Product Change Notification

Change Notification #: 118835-00
Change Title: Intel® Server System M50CYP1UR204 and Intel® Server System M50CYP2UR312 PCN 118835-00, Product Design, Switch change and Label Update
Date of Publication: January 10, 2022

Figure 1. Switch S5_2 before change (ON)

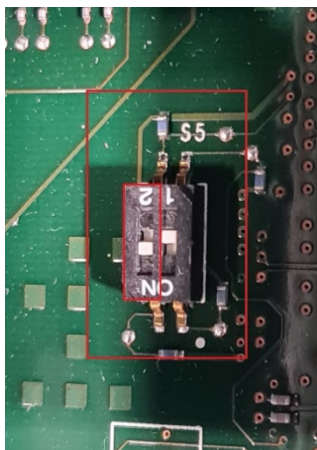
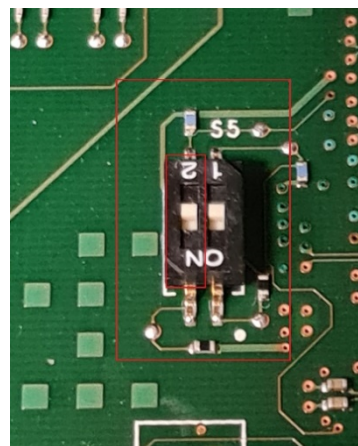
- Move S5_2 switch from “ON” to “OFF” position on the motherboard to enable functionality of Intel® Trusted Execution Technology (Intel® TXT).

Figure 3. Location of S5 Switch

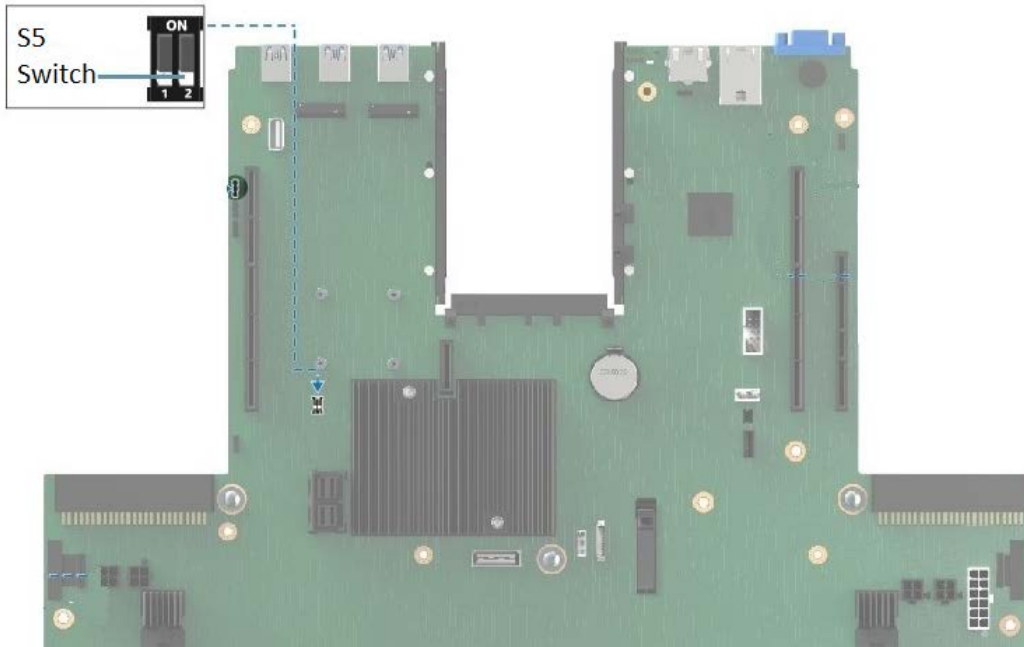
The location of S5 switch can be observed in the picture below:
